**STAFF REPORT:** 10/12/2022 REGULAR MEETING

**APPLICATION NUMBER:** #22-8057

**ADDRESS:** 691 CANFIELD

**SCOPE:** REHABILITATE DWELLING, INSTALL PAVERS AT PATIO AND DRIVEWAY (WORK STARTED WITHOUT APPROVAL)

691 W CANFIELD  
MASONRY CHIMNEY

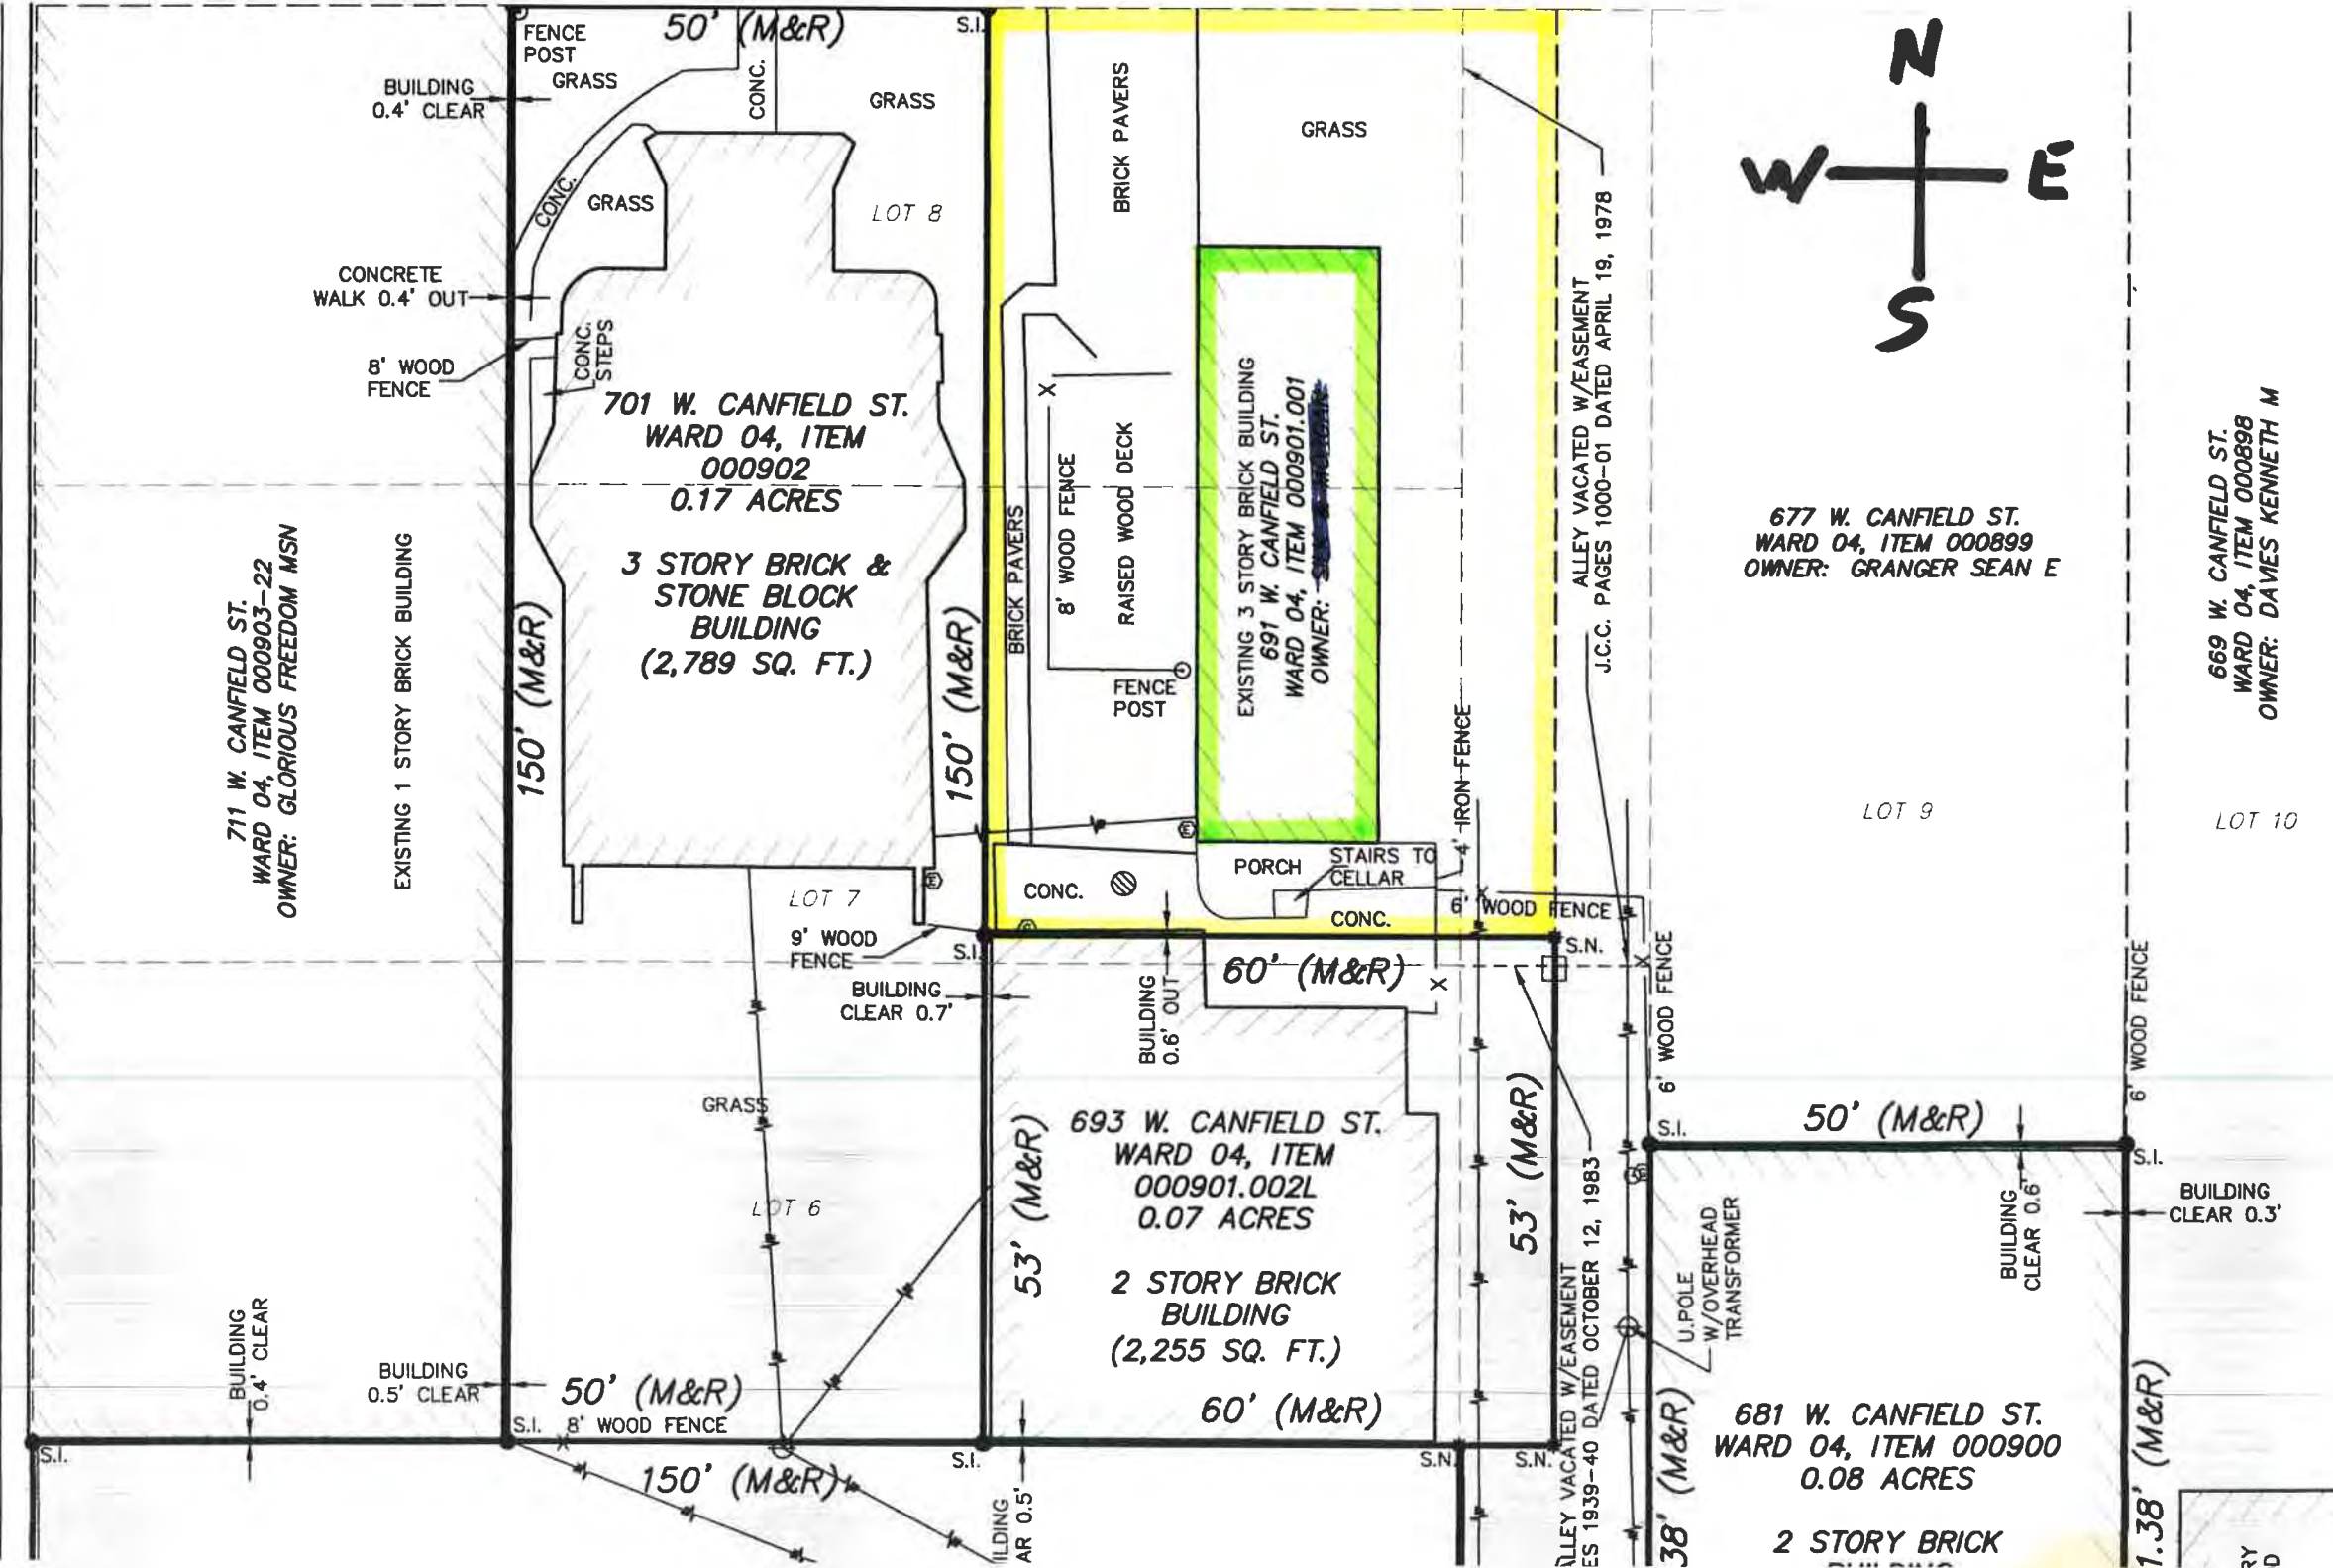
INVESTIGATE STRUCTURAL  
INTEGRITY OF LEANING  
CHIMNEY. DETERMINE IF  
CHIMNEY HAS CRACKED  
AND REMOVE BRICK  
DOWN TO STONE COLLAR,  
OR INTRODUCE CHIMNEY  
BRACE.

691 W CANFIELD  
SITE PLAN

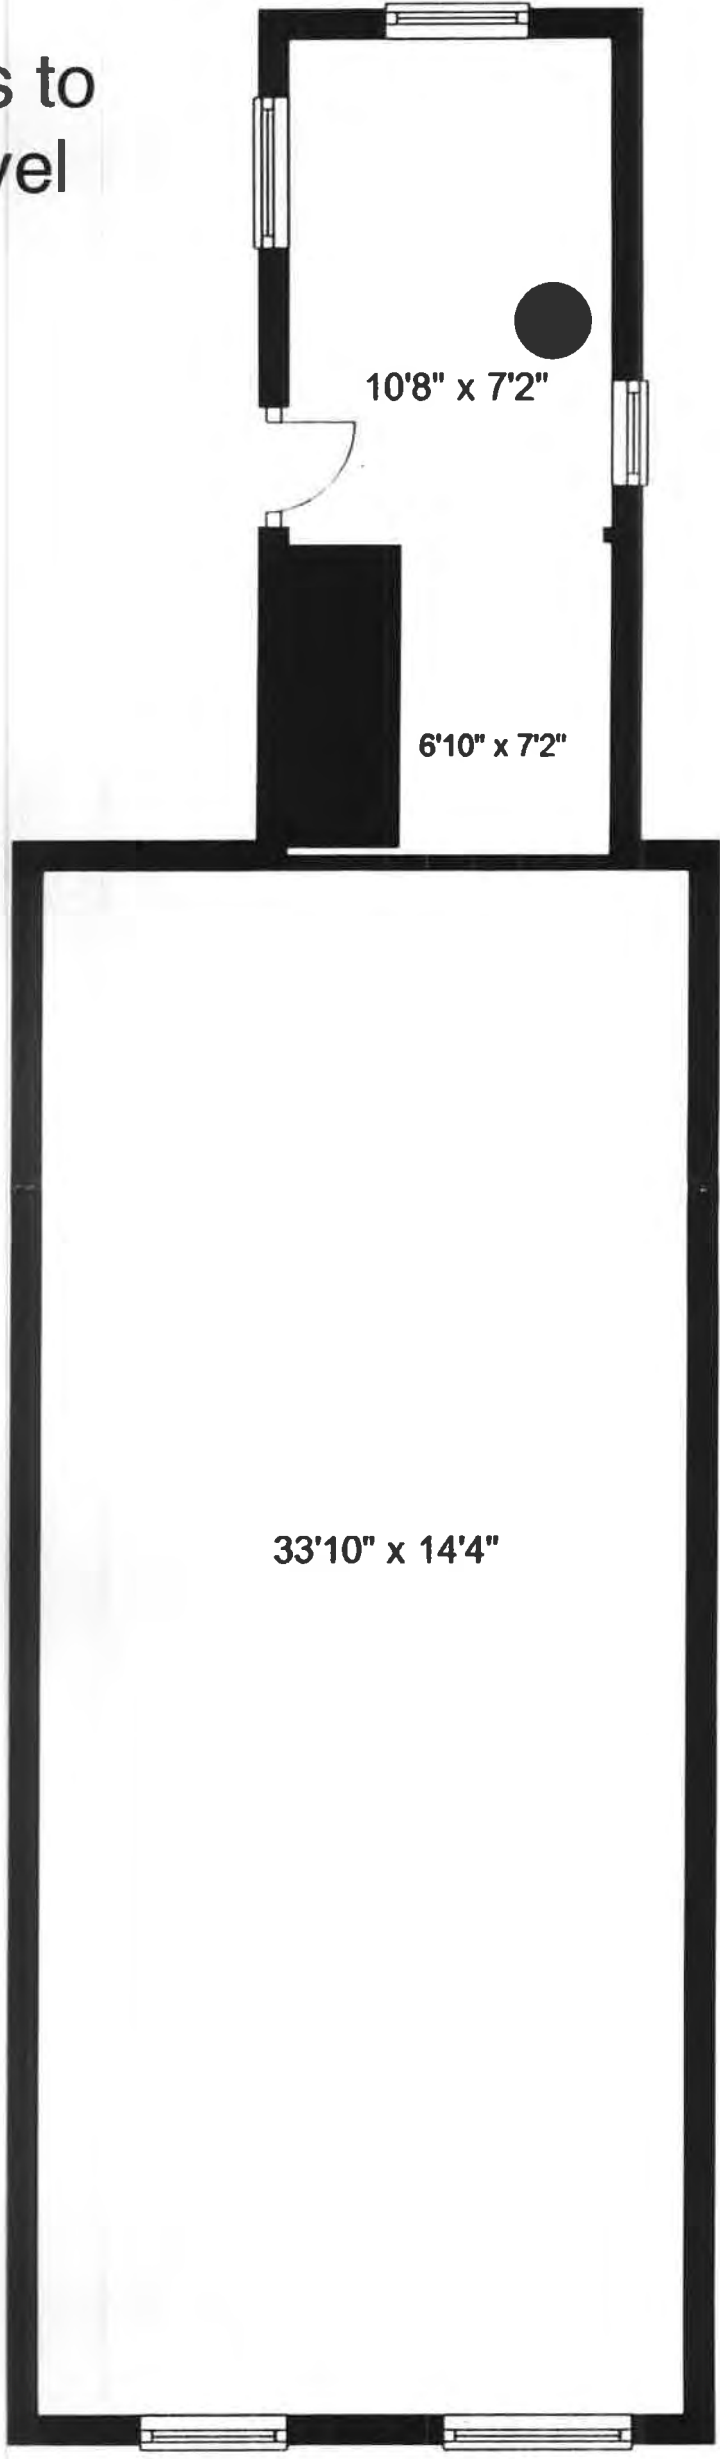
Thank you for your materials. I will review more in depth as soon as I can. Right now, I have a couple questions regarding this site plan:

1. Thank you! This helps to clarify the plan greatly.
2. The key for your fence line (2 black colors) and the fence in the plan (black and blue lines) seem to indicate an overlap of fence types- and I don't see where the metal fence line is located. Can you help clarify the proposed fence installations and types?

3. The pink areas are all for the new stone pavers (from Hart Plaza), correct? So the front yard will fill in areas at on either side of the driveway, correct?

YES TOO MANY LINES AND COLORS. ON THE WEST SIDE WE WERE LOOKING TO INTERSPERSE METAL AND WOOD FENCE. The point of that is that there are a number of windows near grade in the next door house that look directly onto the back patio so we were thinking to mix the fencing from the wood to the metal. I will try to draw something up that illustrates that specifically.

YOU ARE CORRECT DAN HOWEVER WHEN I RETHINK IT, IT WOULD MAKE MORE SENSE TO USE THE HART PLAZA STONE ON THE BACK RIGHT SIDE PATIO AND USE THOSE BRICK PAVERS UP FRONT ON THE DRIVEWAY EXTENSION. All of the pavers need to come up and be re laid and I think the quantities would work. Then we could keep consistent with the brick pavers on the driveway, original walkway and slip over to the hart ones on the side path and the back patios.

691 W CANFIELD  
SOUTH PARTIAL  
ELEVATION

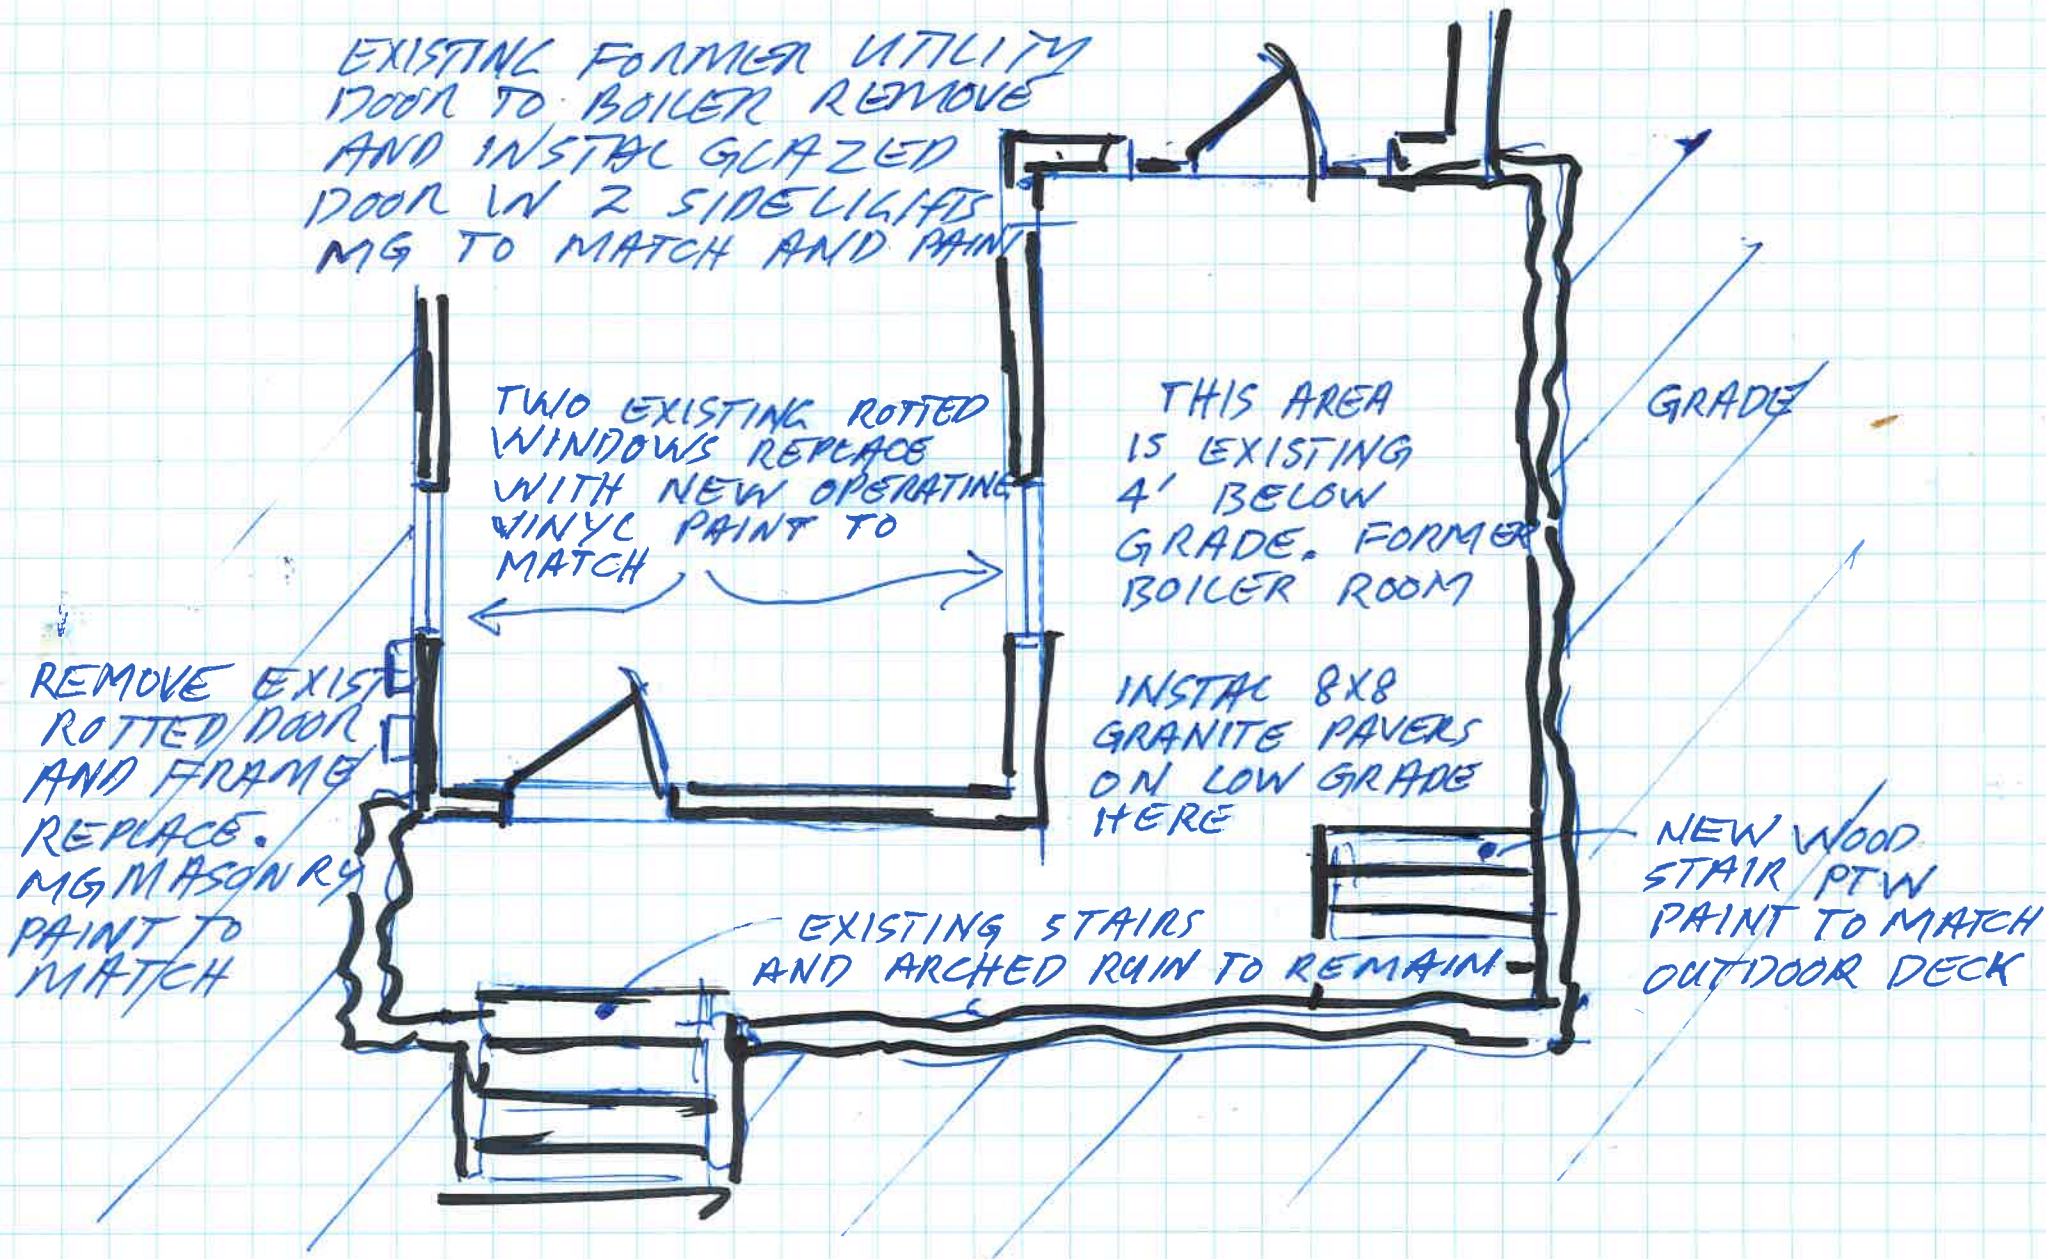
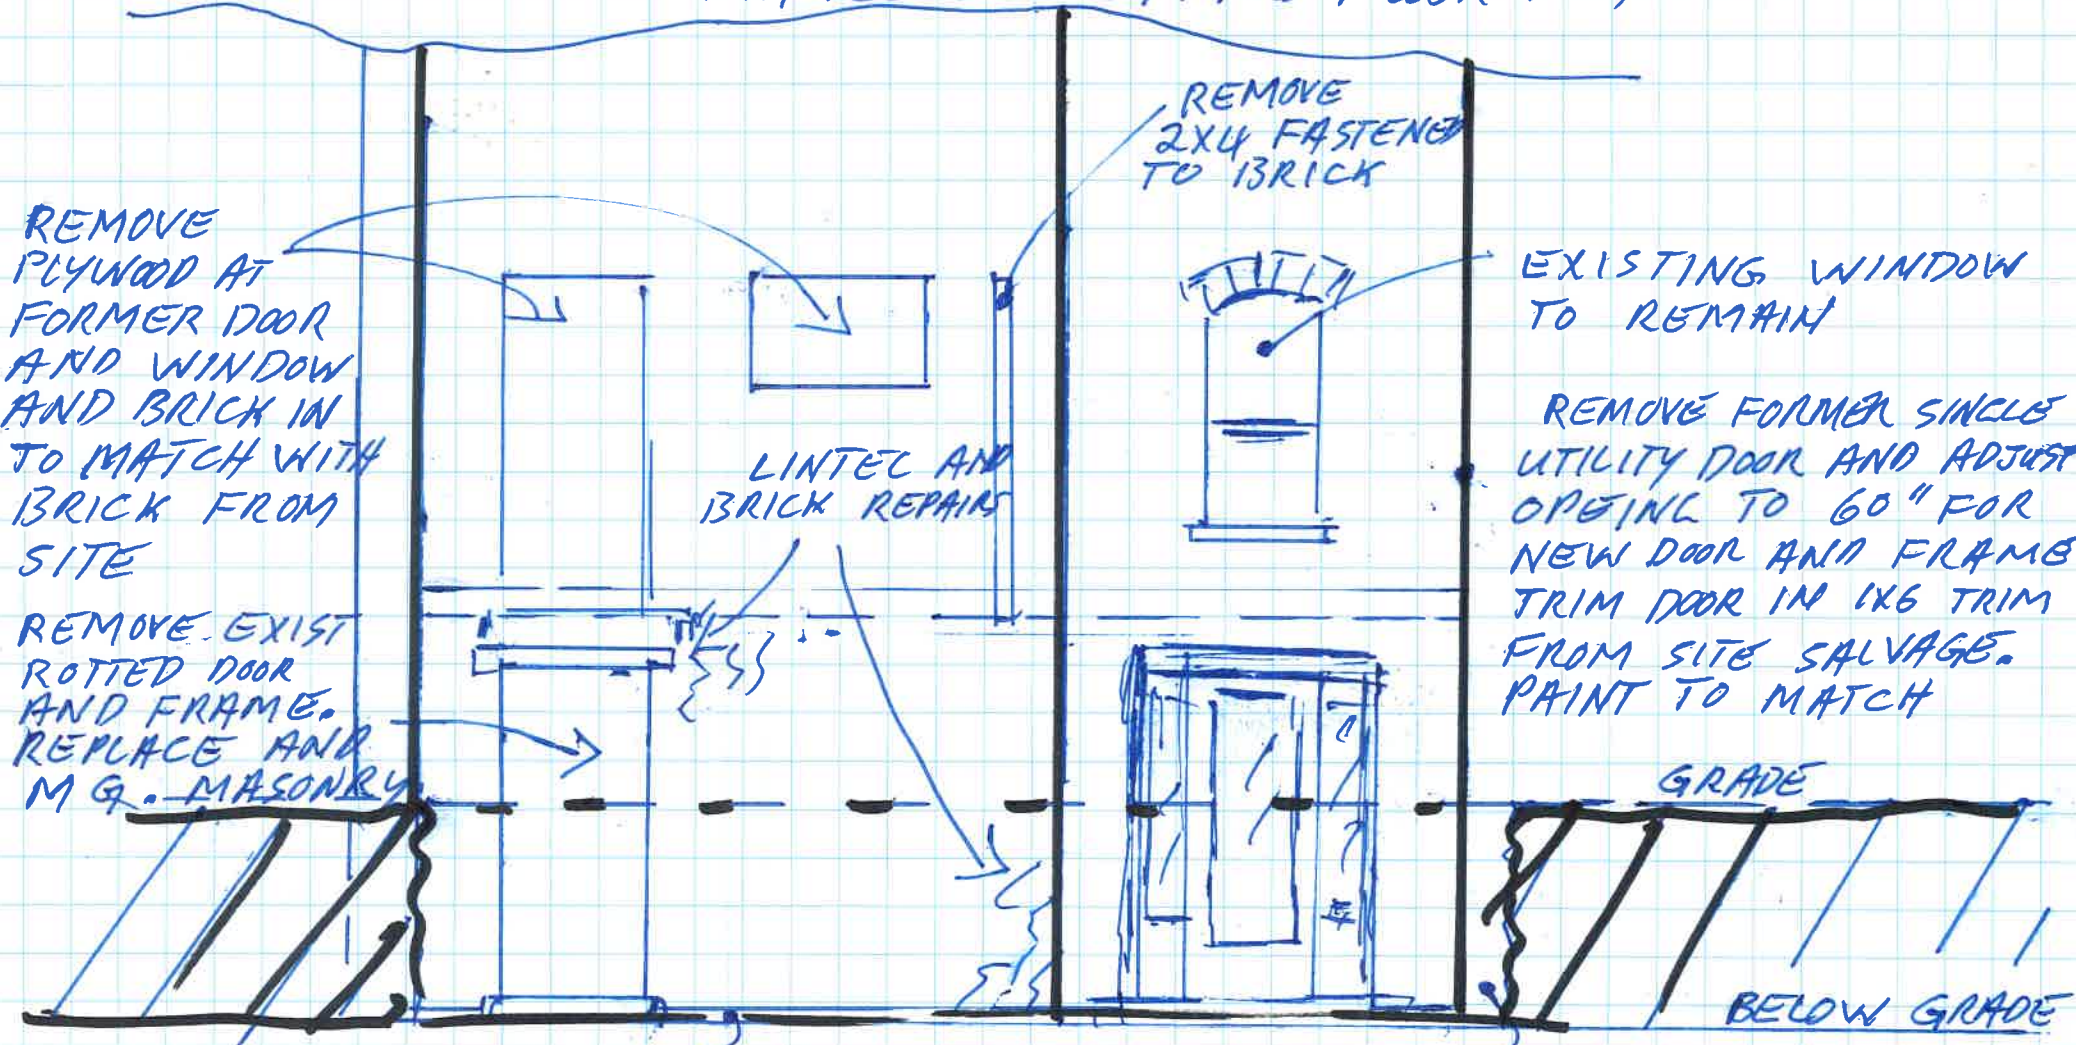
Please find attached rear elevation south facing noting scope of work.

Hopefully this clears up the confusion. I suspect it was difficult from the photos to understand the sunken boiler room ruin back there or whatever it was.
